# Comments and Recommendations One-Year Zoning Bylaw Review

Windsor Park Community League

June 3, 2025

# Example: Row House Front Looks Like the Side of a House

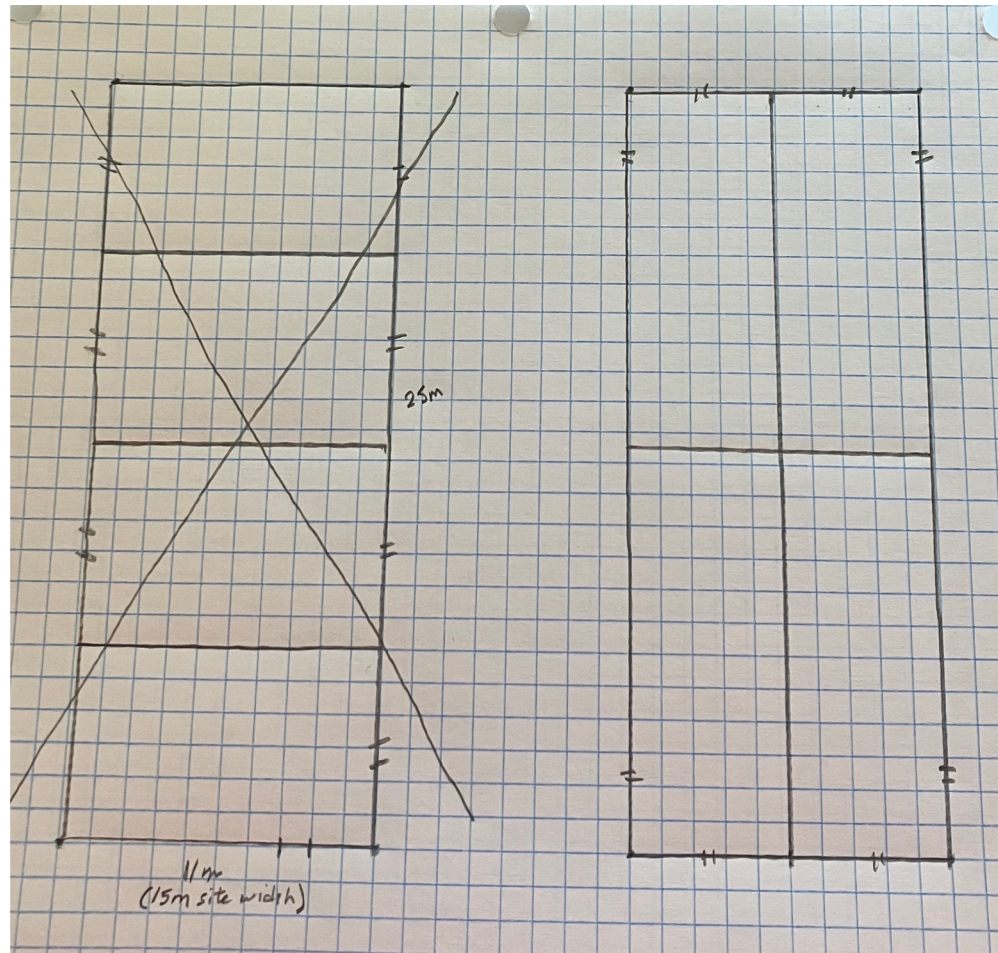
- Articulation on front facades for street and side facing units
- Entrance and Window design regulations for front and side facing units

These are important because front units look like the side of a house
